ATTACHMENT A

Technical Specification

Page Revisions

Consolidated Edison Company of New York, Inc.
Indian Point Unit No. 2
Docket No. 50-247
May, 1982

Figure 3.1-1

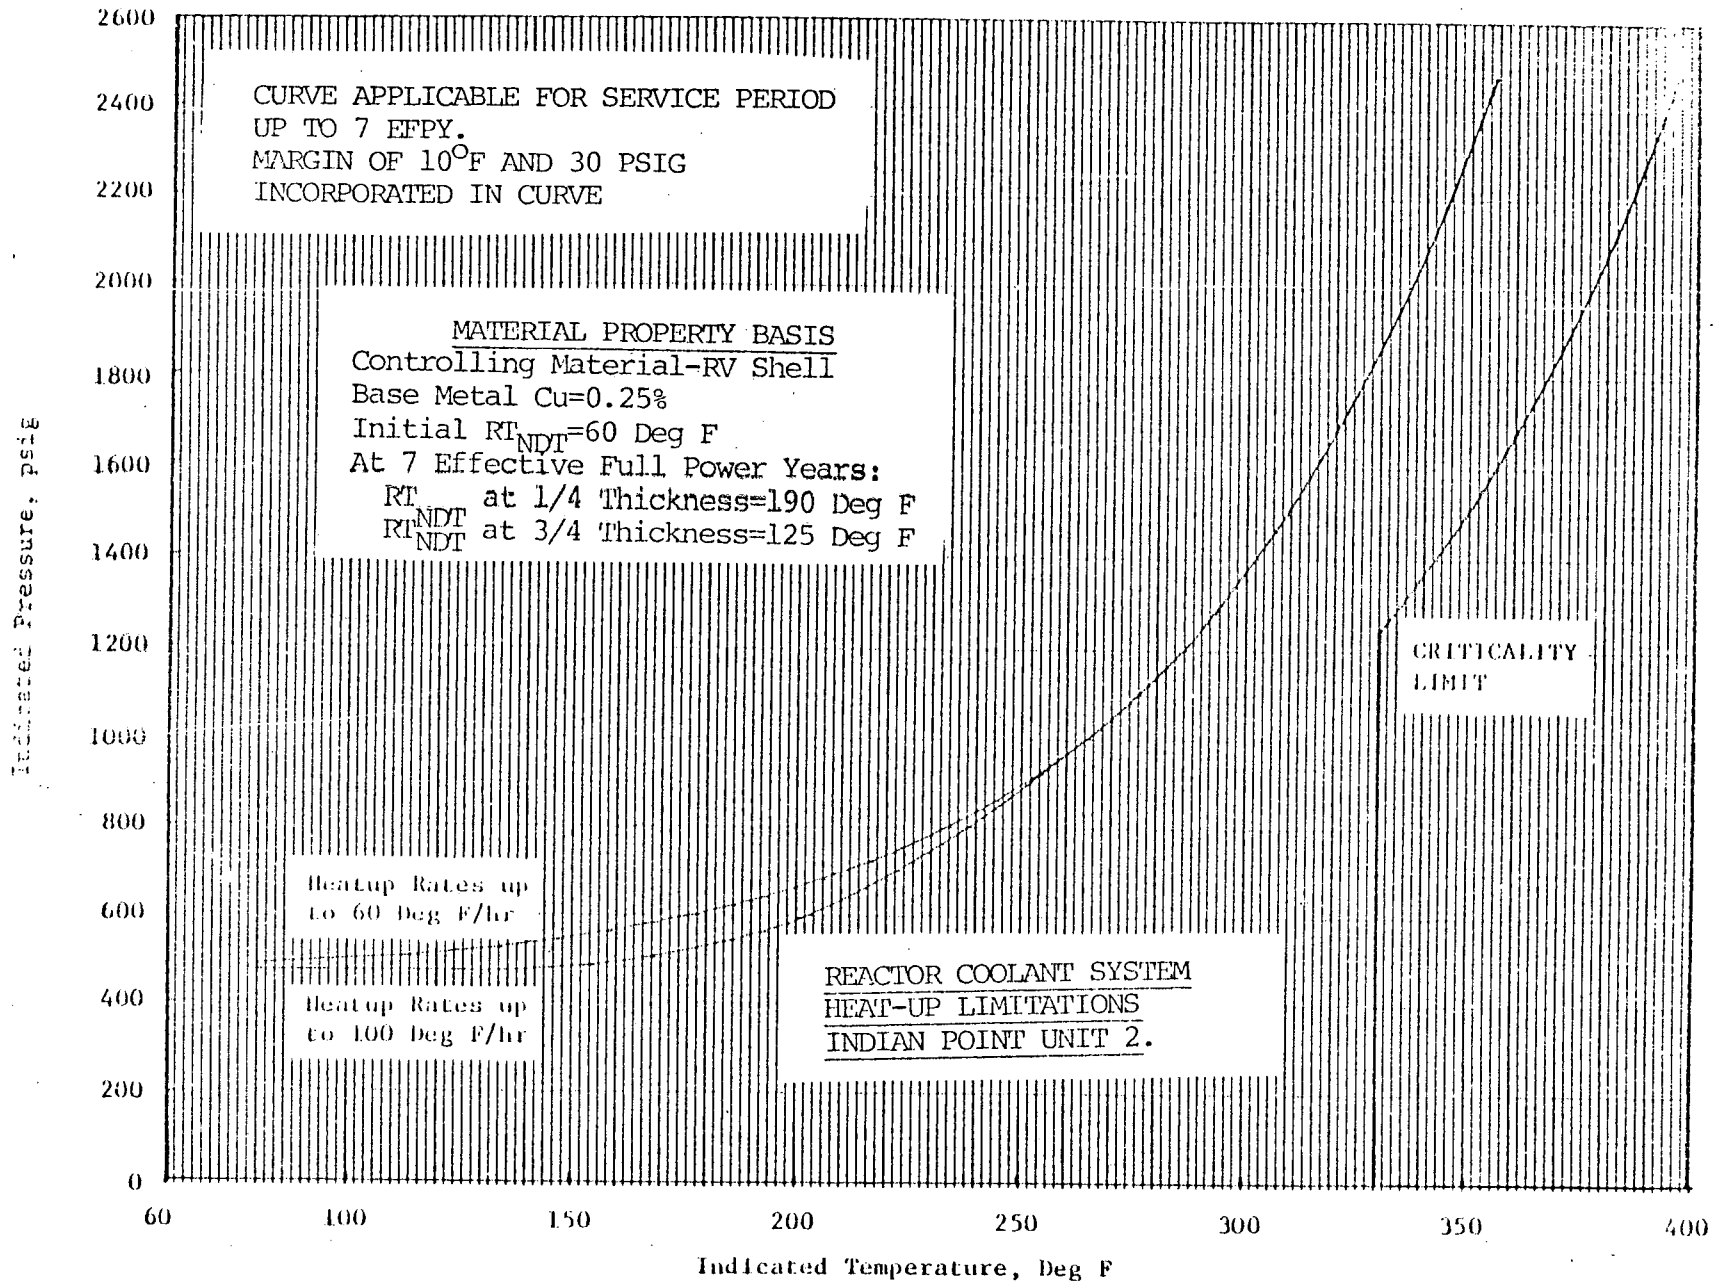
1. The reactor coolant temperature and pressure and system heatup and cooldown rates averaged over one hour (with the exception of the pressurizer) shall be limited in accordance with Figure 3.1-1 and Figure 3.1-2 for the service period up to 7 effective full-power years. The heatup or cooldown rate shall not exceed 100°F/hr.

- a. Allowable combinations of pressure and temperature for specific temperature change rates are below and to the right of the limit lines shown. Limit lines for cooldown rates between those present may be obtained by interpolation.

- b. Figure 3.1-1 and Figure 3.1-2 define limits to assure prevention of non-ductile failure only. For normal operation other inherent plant characteristics, e.g., pump heat addition and pressurizer heater capacity may limit the heatup and cooldown rates that can be achieved over certain pressure-temperature ranges.

Figure 3.1-2

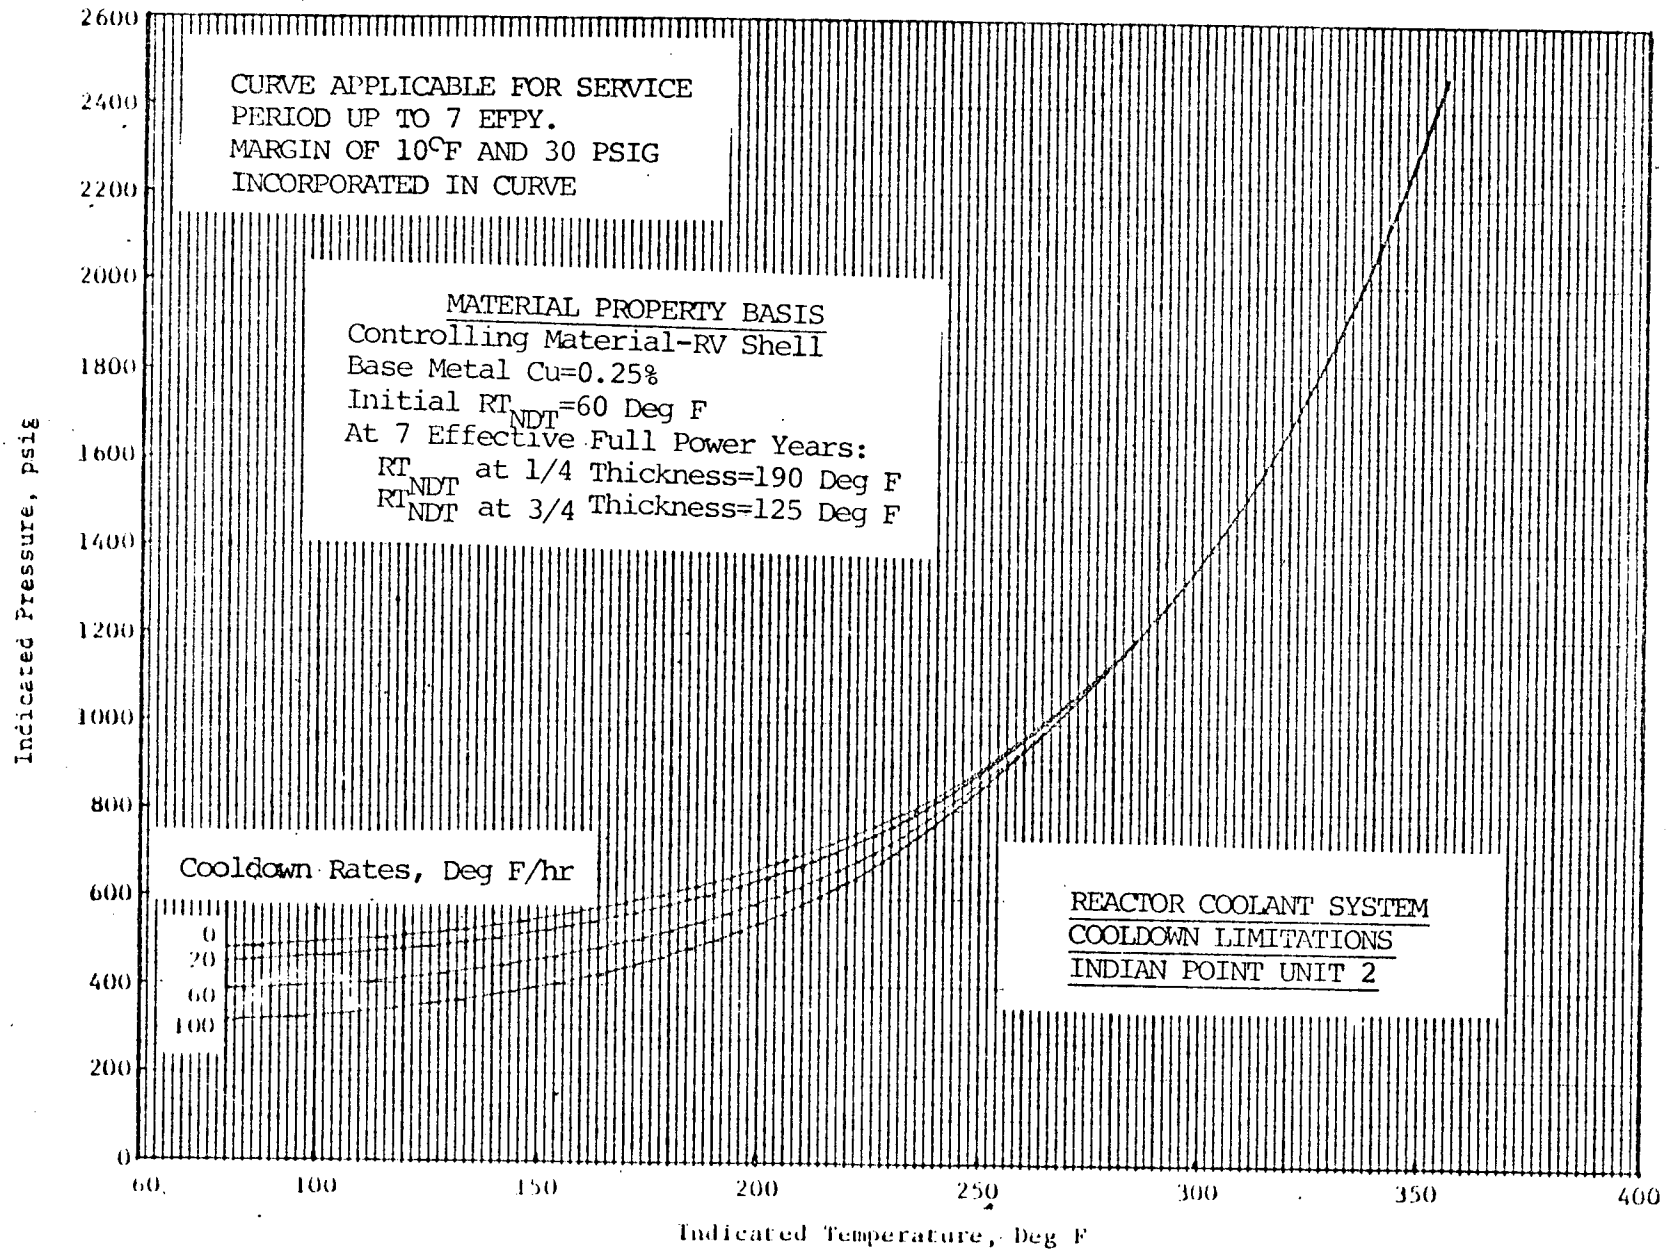
Because operation control is on coolant temperature, and cooldown rate may vary during the cooldown transient, the limit curves shown in Figure 3.1-2 represent a composite curve consisting of the more conservative values calculated for steady state and the specific cooling rate shown.

- a) When the Reactor Coolant System is closed after it has been opened, the system will be leak tested at not less than 2335 psig at NDT requirements for temperature.
- b) When Reactor Coolant System modifications or repairs have been made which involve new strength welds on components, the new welds shall meet the requirements of the applicable version of ASME Section XI as specified in the Con Edison Inservice Inspection and Testing Program in effect at the time.
- c) The Reactor Coolant System leak test temperature-pressure relationship shall be in accordance with the limits of Figure 4.3-1 for heatup for the first seven (7) effective full-power yrs. of operation. Figure 4.3-1 will be recalculated periodically. Allowable pressures during cooldown for the leak test temperature shall be in accordance with Figure 3.1-2.

Figure 4.3-1

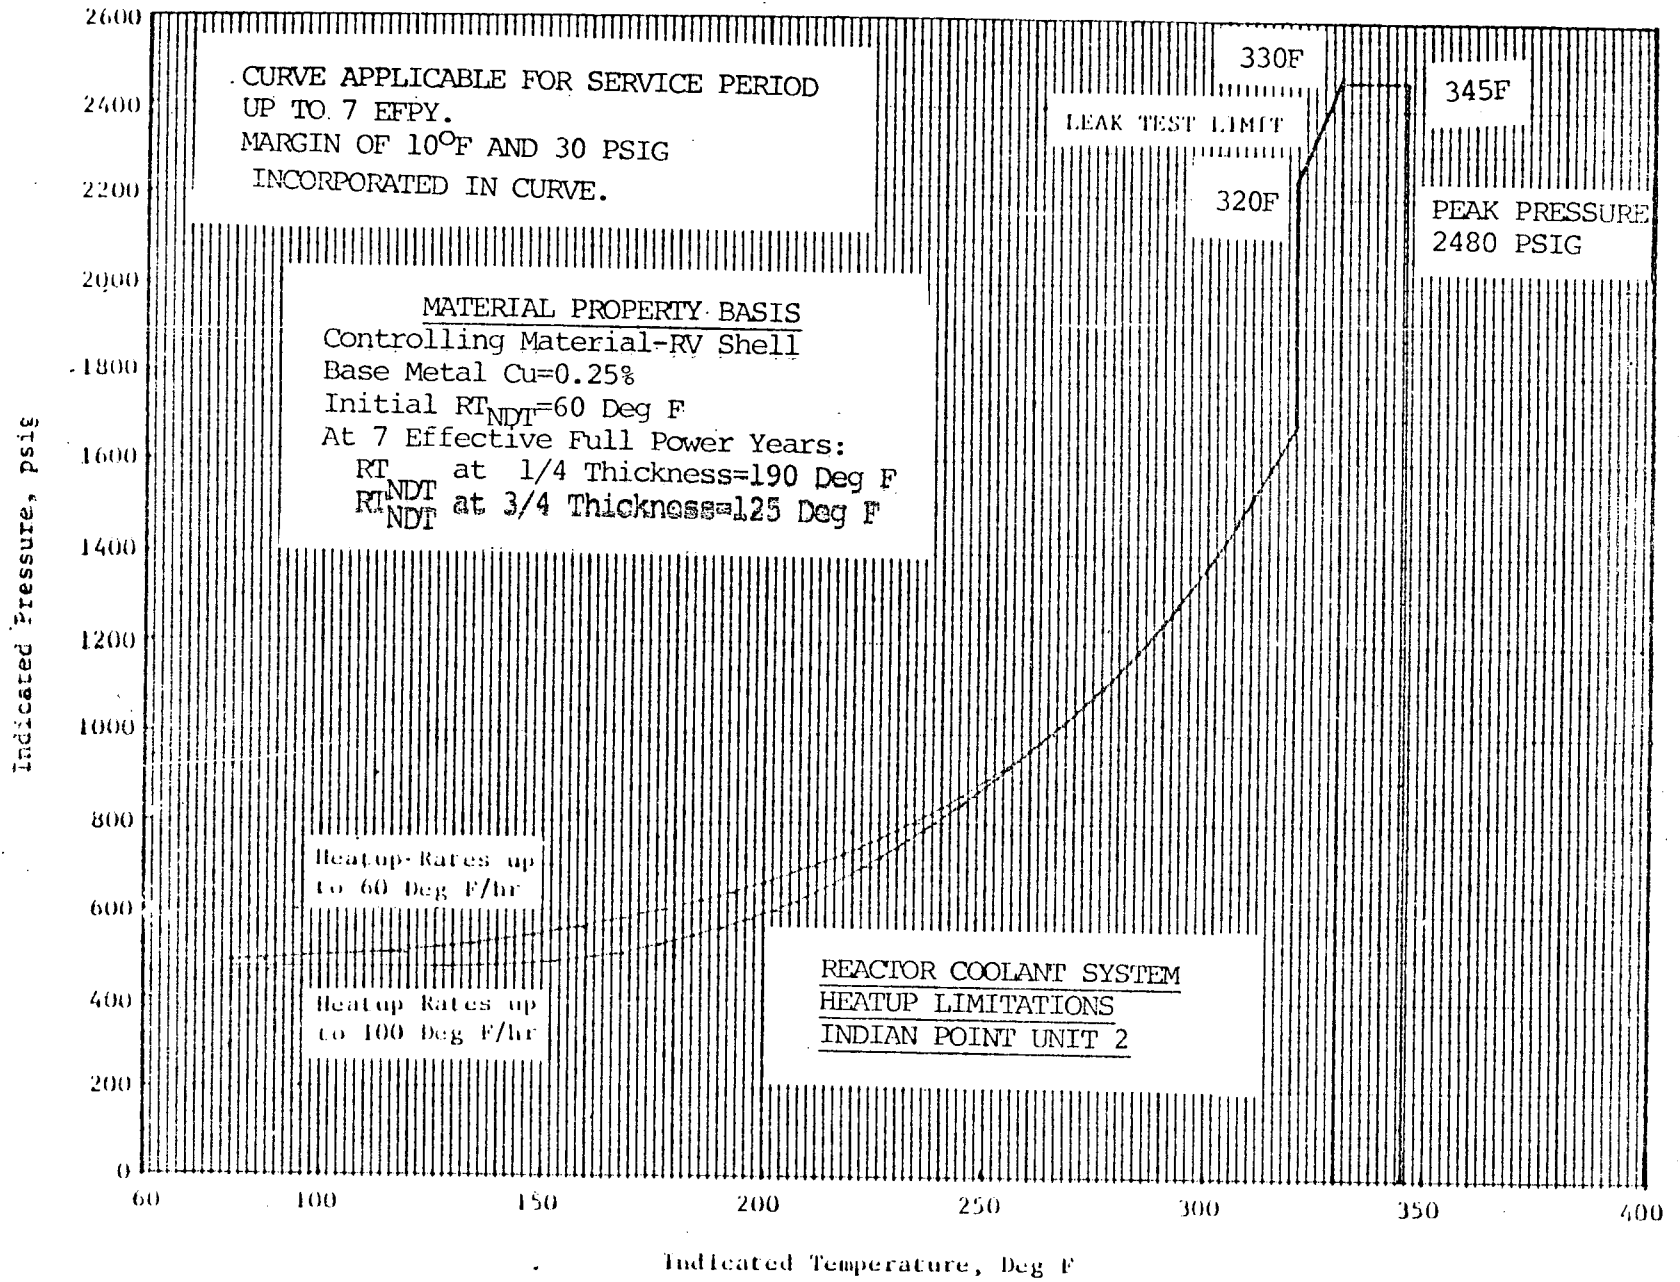
The inservice leak temperatures are shown on Figure 4.3-1. The temperatures are calculated in accordance with ASME Code Section III, 1974 Edition, Appendix G. This Code requires that a safety factor of 1.5 times the stress intensity factor caused by pressure be applied to the calculation.

For the first seven (7) effective full-power years, it is predicted that the highest RT_{NDT} in the core region taken at the 1/4 thickness will be 190°F. The minimum inservice leak test temperature requirements for periods up to seven (7) effective full-power years are shown on Figure 4.3-1.

The heatup limits specified on the heatup curve, Figure 4.3-1, must not be exceeded while the reactor coolant is being heated to the inservice leak test temperature. For cooldown from the leak test temperature, the limitations of Figure 3.1-2 must not be exceeded. Figures 4.3-1 and 3.1-2 are recalculated periodically, using methods discussed in WCAP-7924A and results of surveillance specimen testing, as covered in WCAP-7323.
